PROJECT: LITTLE ST. JAMES
SHEET TITLE: KITCHEN ELEV./SECTION
SHEET 5 OF 9

APPROVED AS NOTED 11.10.2010
MARK REFF

KITCHEN SECTIONS

SCALE: AS NOTED DRAWN BY KAS	PROJECT: UTILE ST. JAMES SHEET TITLE: ISLAND ELEV./SECTION SHEET 8 OF 9	REVISED:	DATE: 10/25/10 SHEET #: W-8
------------------------------	---	----------	--------------------------------

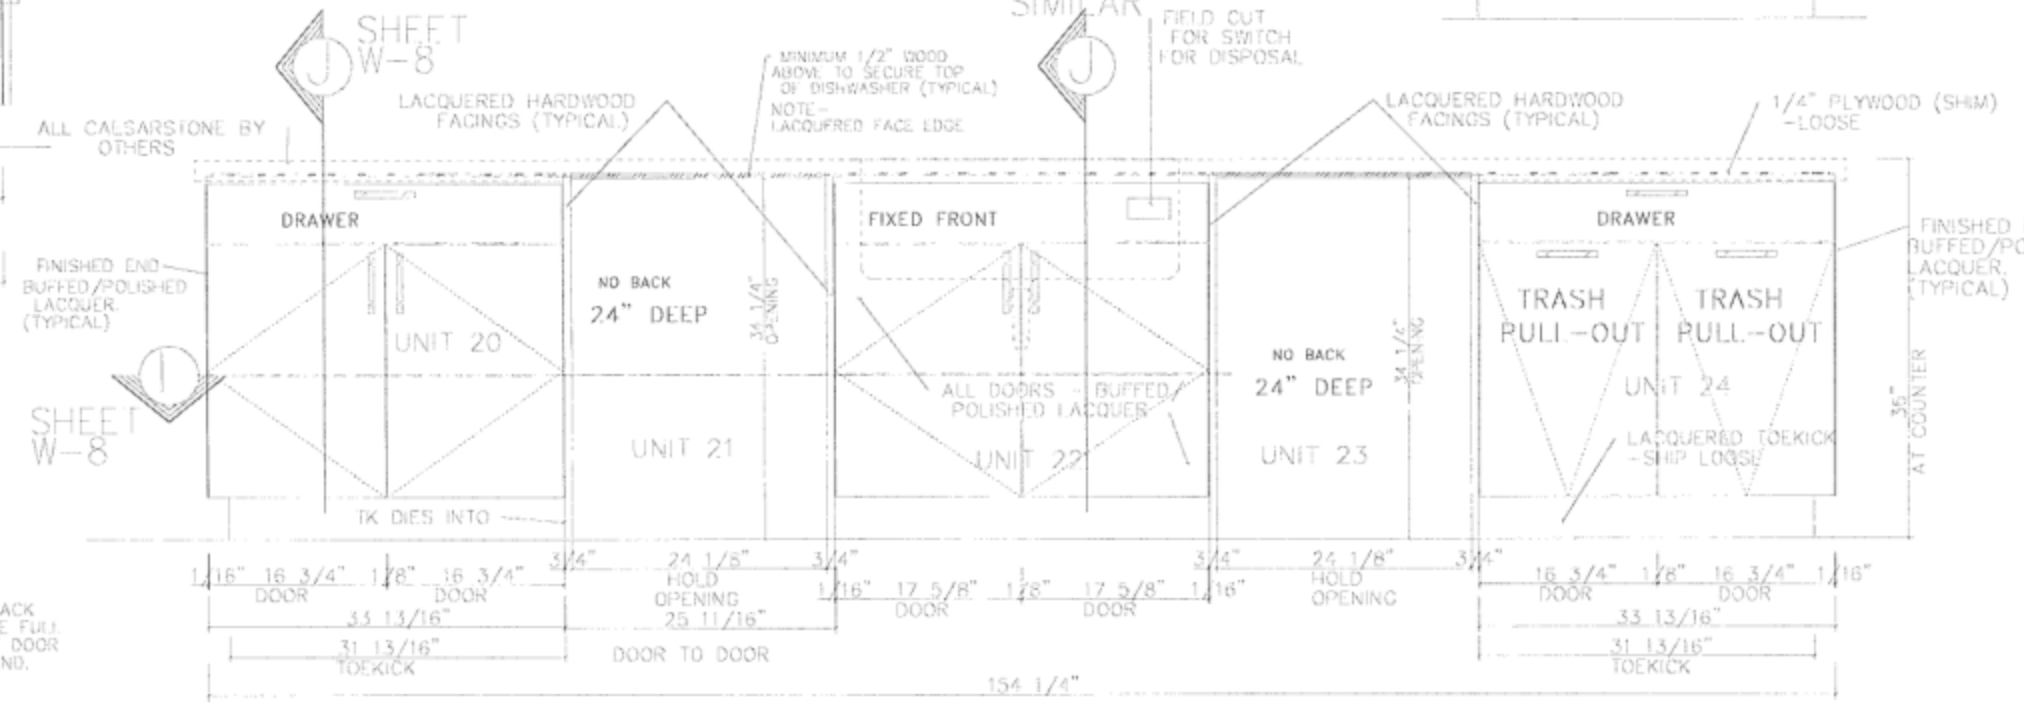
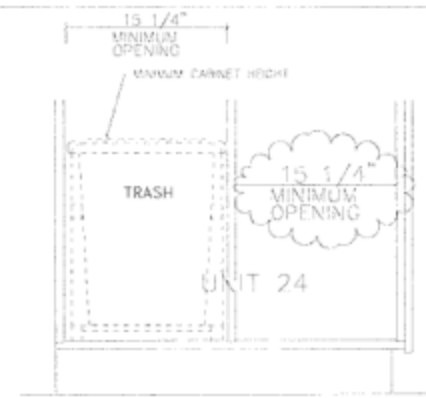
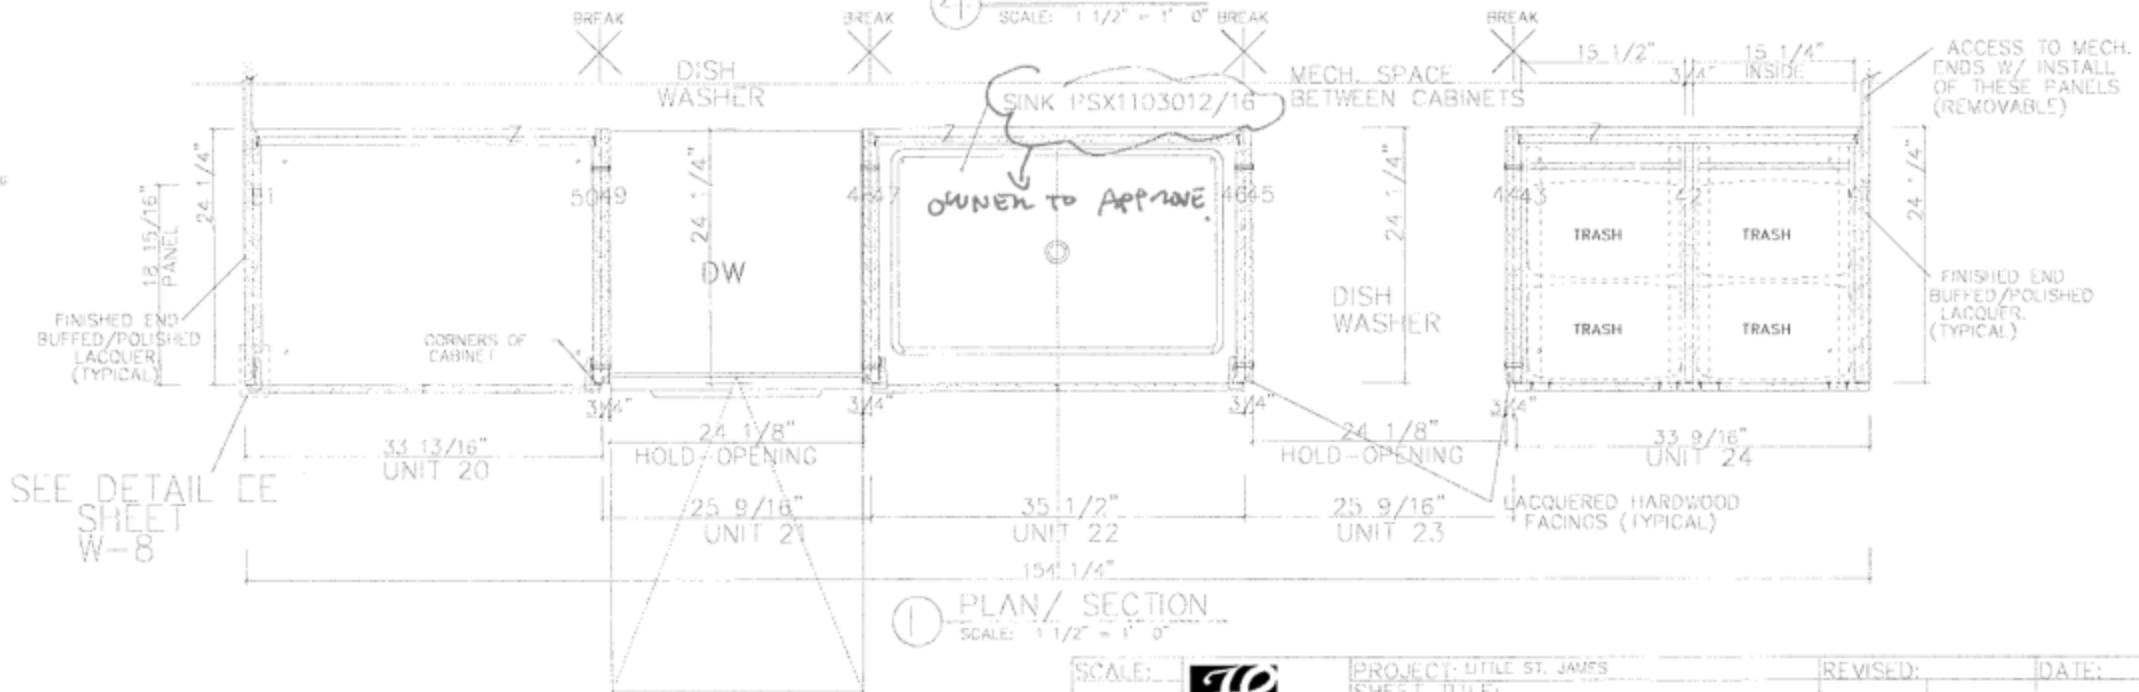
NOTE -
WILL ISLAND BE OK 11 1/4" LONGER?
DOUBLE WASTE BIN SOFT-CLOSE GLIDES
REQUIRE MINIMUM 15 1/4" OPENING.

PROVIDE DESIGNER W/ FINISH SAMPLES
FOR APPROVAL PRIOR TO FABRICATION
OWNER TO APPROVE PLUMBING SPEC.

SCALE:	PROJECT: LITTLE ST. JAMES	REVISED:	DATE:
AS NOTED	SHEET TITLE:		10/25/10
DRAWN BY:	ISLAND ELEV./SECTION		SHEET #:
KAS	SHEET 9 OF 9		W-9

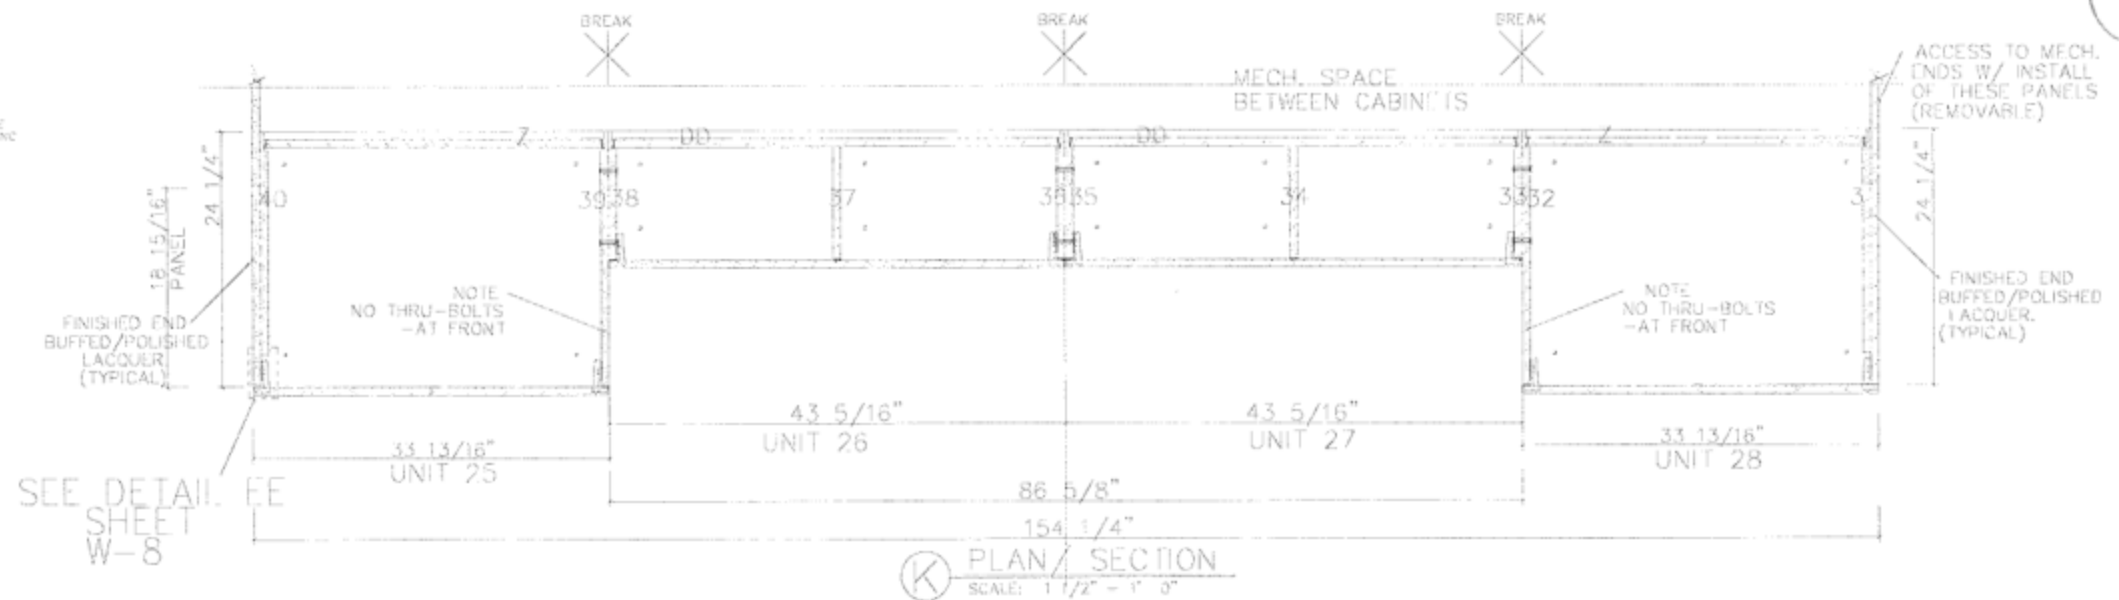
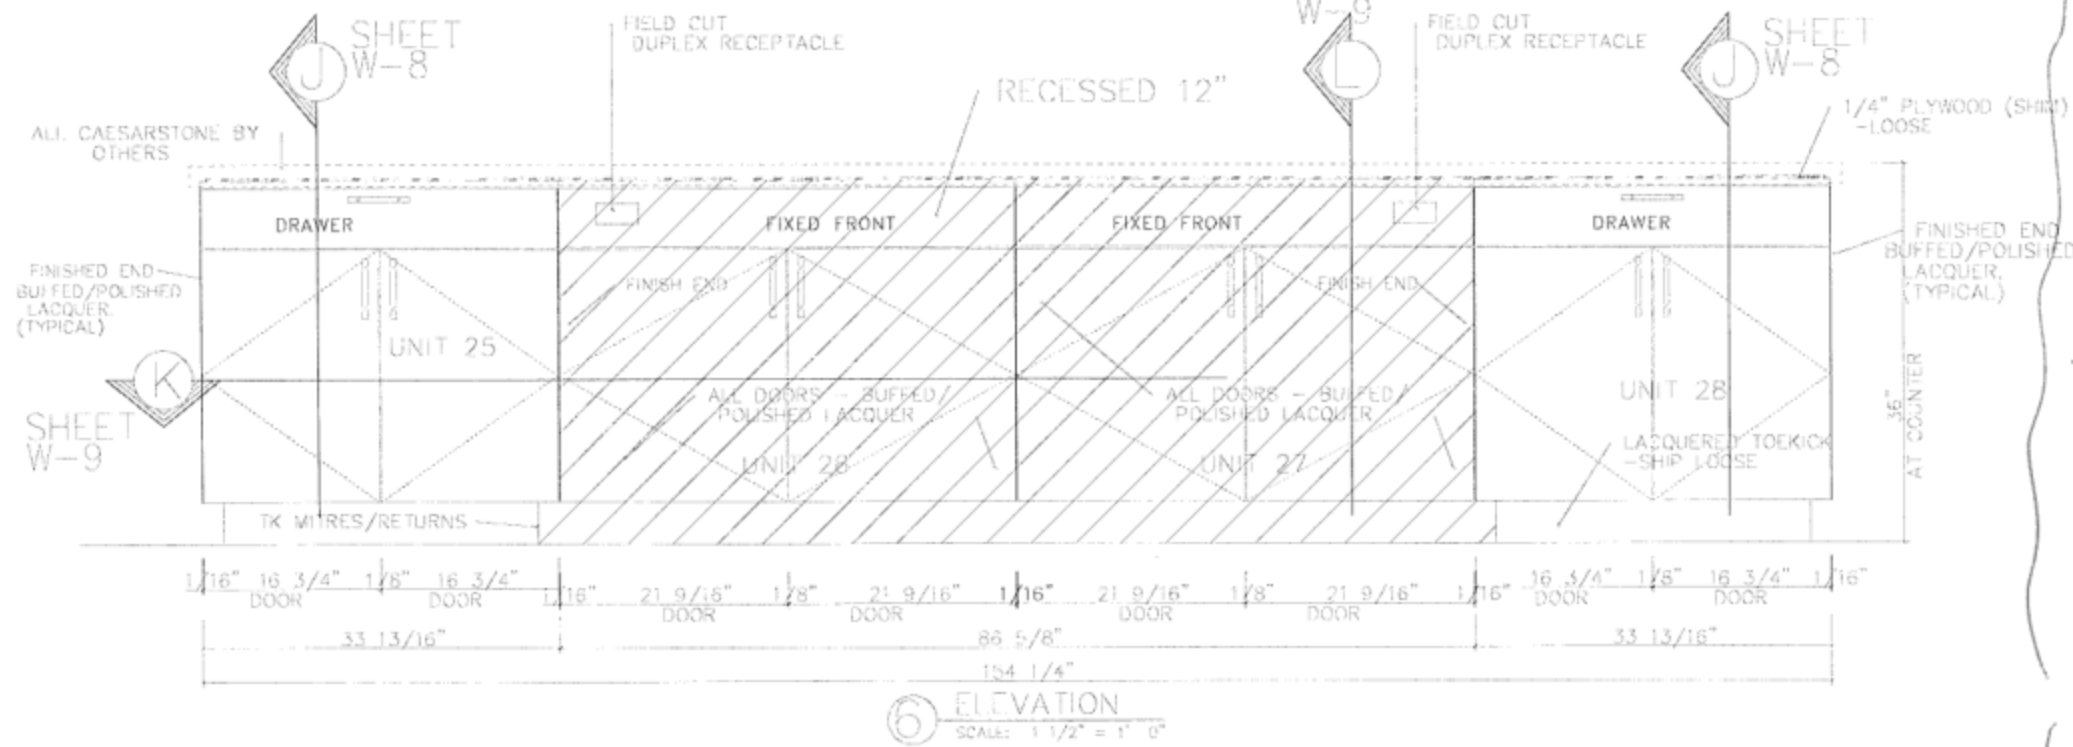
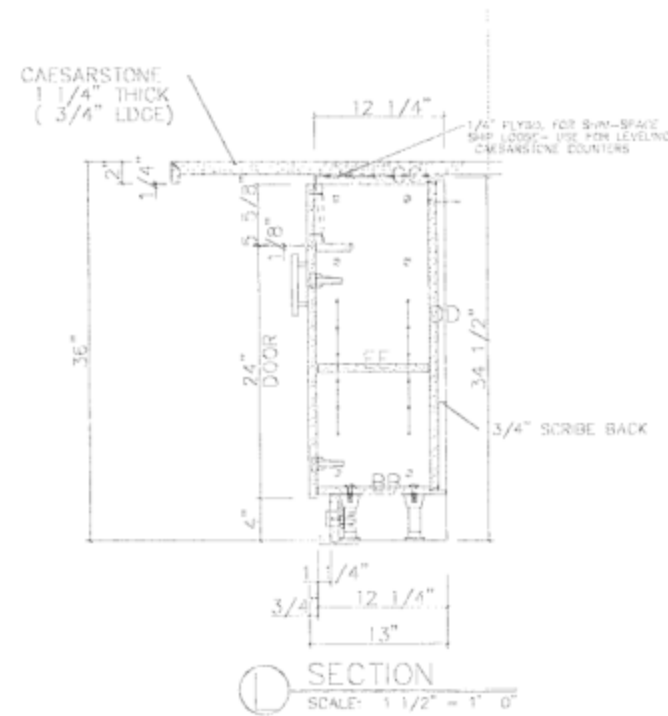
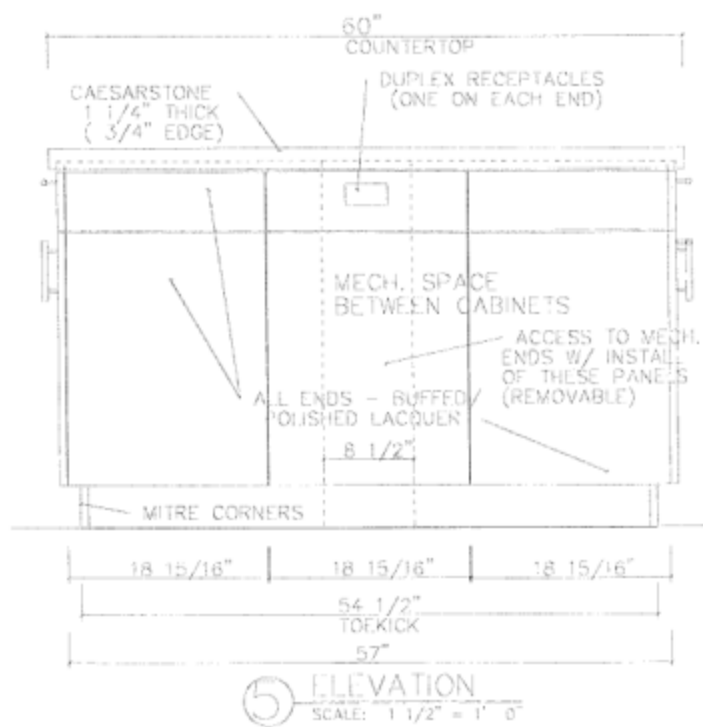
NOTE -- WILL ISLAND BE OK 11 1/4" LONGER? --> CONFIRM W/ OWNER.

PROVIDE DESIGNER W/ FINISH SAMPLES.
FOR APPROVAL - PRIOR TO CONSTRUCTION.
OWNER TO APPROVE SIZE INCREASE
OF ISLAND.
